Equalizer Nomenclature, Description, and Eye Diagram Generation

Version 1.1g

IEEE 802.3dj May Meeting

- This presentation suggest changes to the draft specification that address
 - Equalizer Nomenclature
 - Generation of the eye diagram
 - Synchronization of the test pattern with the input to the equalizer
 - Location of the histograms
 - Noise description
- The goal was to remove ambiguity with minimal changes to the existing text

Proposed Changes to p.479

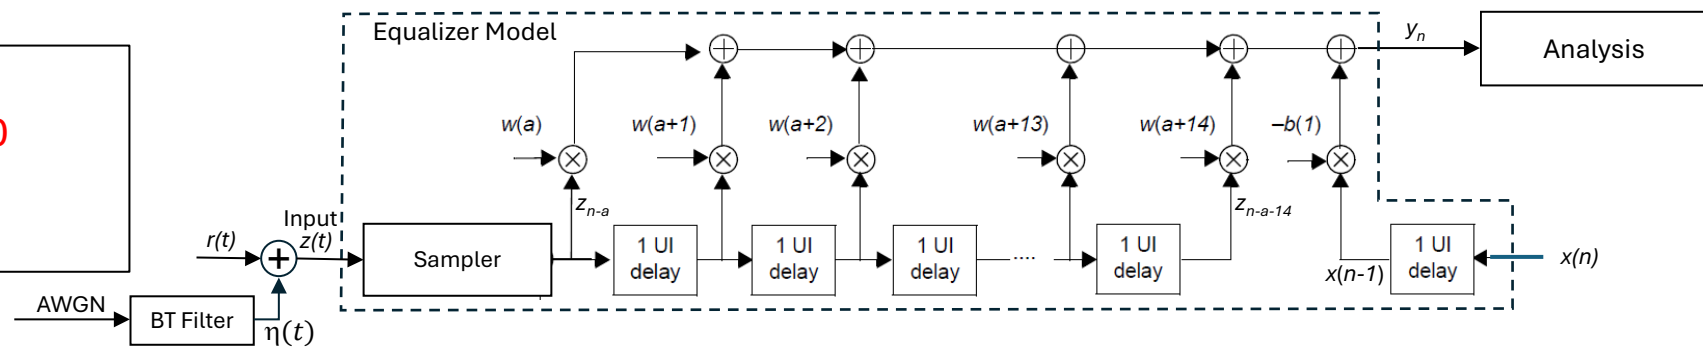
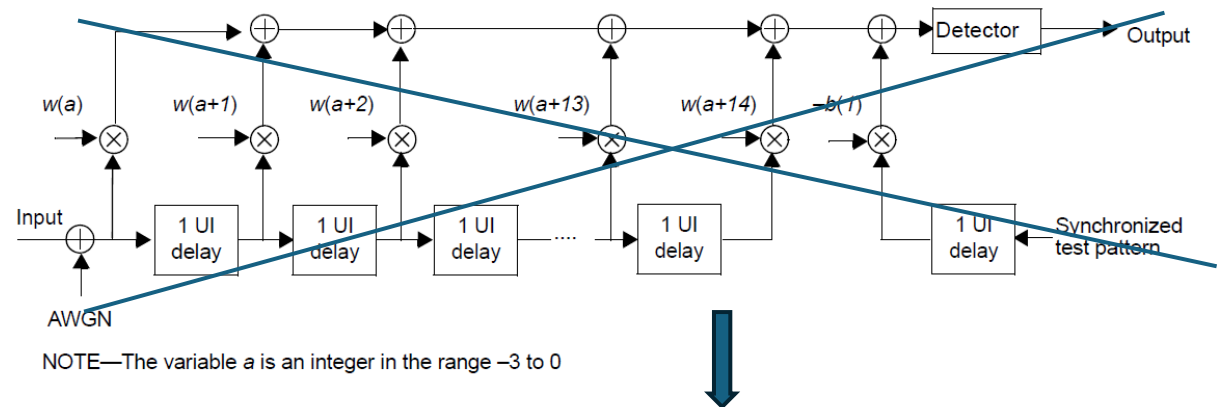
The reference equalizer is a T-spaced discrete-time equalizer with 15 feedforward taps and a single decision feedback tap, where T is the symbol period. Equalizer coefficient constraints are given in Table 180-16. The reference equalizer may be implemented in the oscilloscope. The decisions fed back in the equalizer are modeled as being correct, so the equalizer is modeled as shown in Figure 180-10, where $x(n)$ is the n^{th} symbol in the test pattern sequence, $r(t)$ is the output of the reference receiver defined in 180.9.2, $\eta(t)$ is colored Gaussian noise, $z(t) = r(t) + \eta(t)$, $z_n = z(nT + \phi)$, where $0 \leq \phi < T$, and y_n is the equalizer output corresponding to $x(n)$. The Bessel-Thomson (BT) filter shown is identical to that in 180.9.2. The received signal $r(t)$ is aligned with the test pattern such that $r(nT)$ corresponds to $x(n)$.

The reference equalizer is a 15-tap, T-spaced, feed-forward equalizer (FFE), followed by a 1-tap decision feedback equalizer (DFE), where T is the symbol period, with equalizer coefficient constraints as shown in Table 180-16. The reference equalizer may be implemented in the oscilloscope.

Figure 180-11—Illustration of the TDECQ measurement

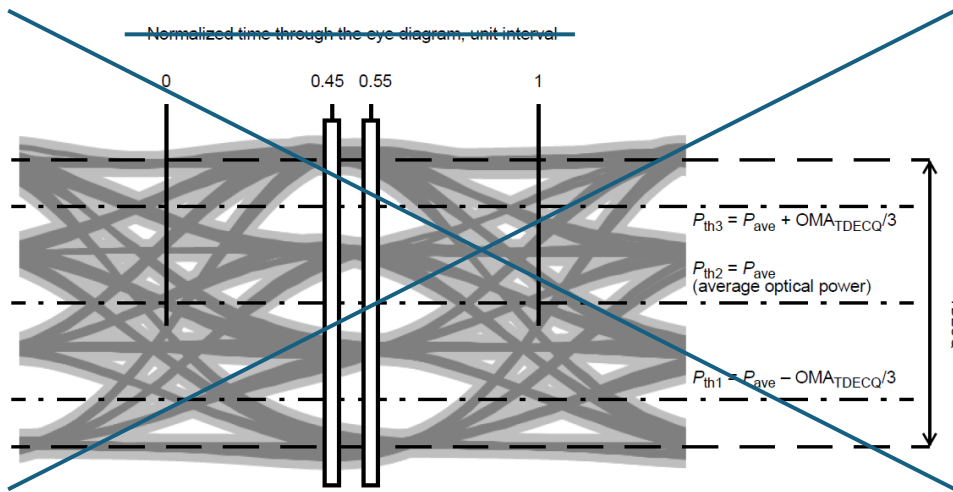
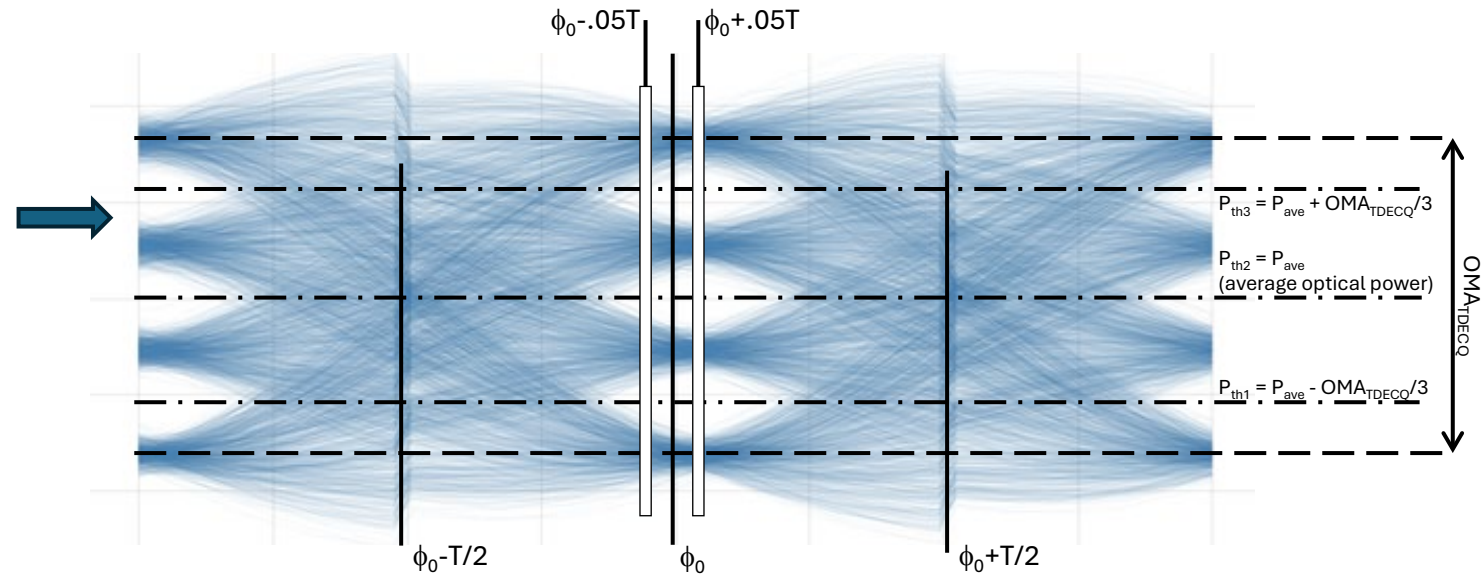
Two vertical histograms are measured through the eye diagram, nominally centered at ~~0.45 UI and 0.55 UI~~. Each of the histogram windows spans all of the modulation levels of the eye diagram, as illustrated in Figure 180-11. The precise time position of the pair of histograms is adjusted to minimize TDECQ while keeping the histograms spaced 0.1 UI apart.

~~0.45 UI and 0.55 UI~~ → .05 UI before and after sampling phase ϕ_0

Figure 180–10—TDECQ reference equalizer functional model

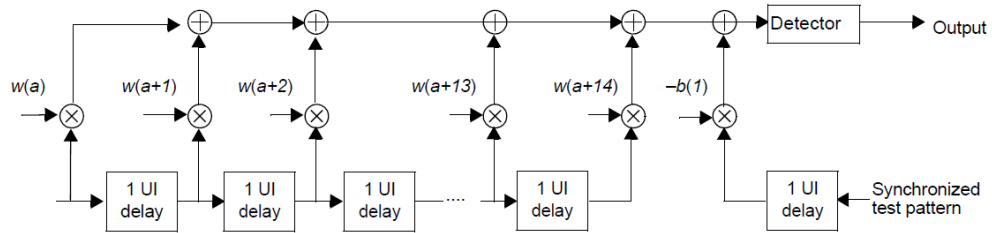
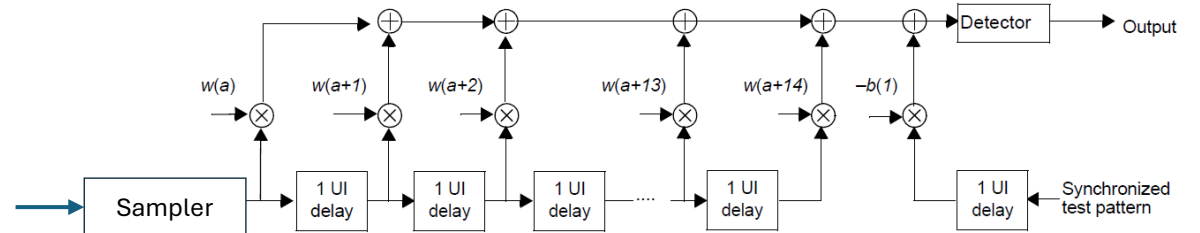
- 1) Continuous time equalizer

- Taps are adjusted based on 1UI - spaced samples
- Components shown are ideal (infinite bandwidth)

- 2) Discrete time equalizer

- 1UI –spaced Sampler is at the input
- For a given tap setting, the phase of the sampler can be swept to produce the eye diagram

Figure 180-11—Illustration of the TDECQ measurement

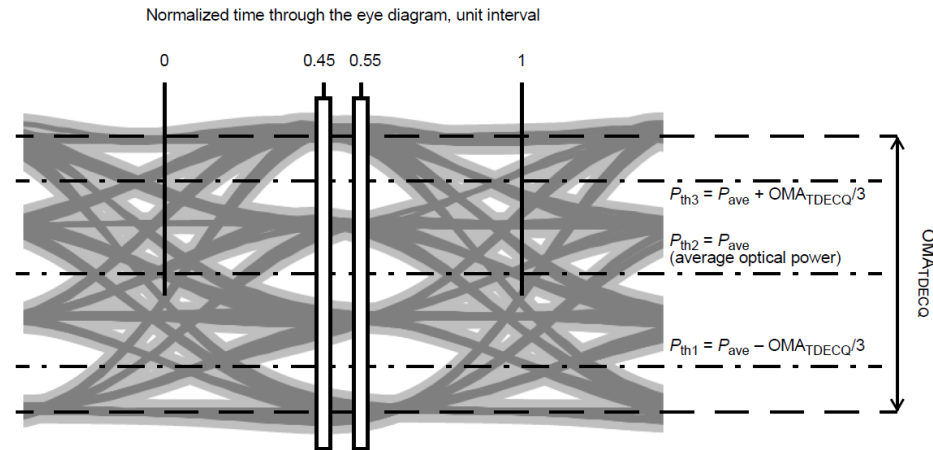
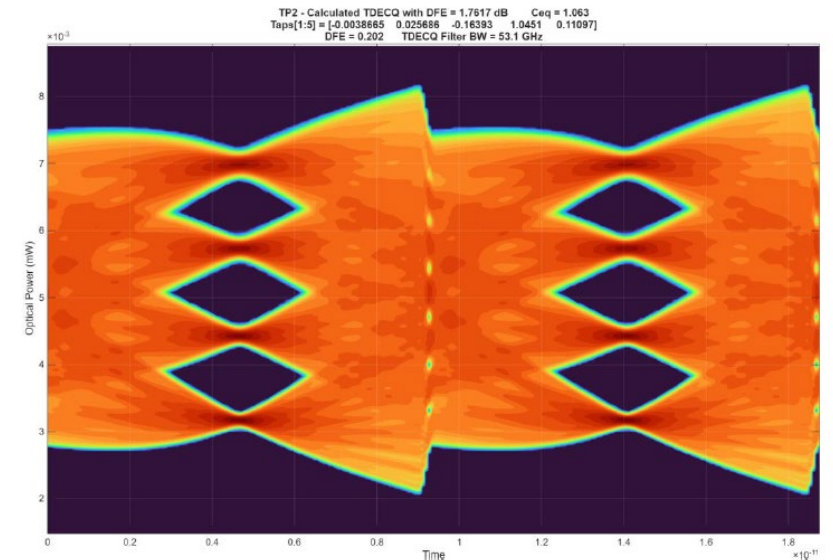
- However we define it, we need to include the “bat-wing” if we show the eye diagram
 - This is a unique feature of the DFE eye diagram. The amount added to the waveform is constant over 1UI.
- Timing: The value must change outside of the two histogram windows
 - Nominally $\frac{1}{2}$ UI from the center eye opening is a good choice
 - We need to say something about this in the text
 - Perhaps “1/2 UI from the nominal point at which the TDECQ is measured”
 - This needs better description in the text and figure
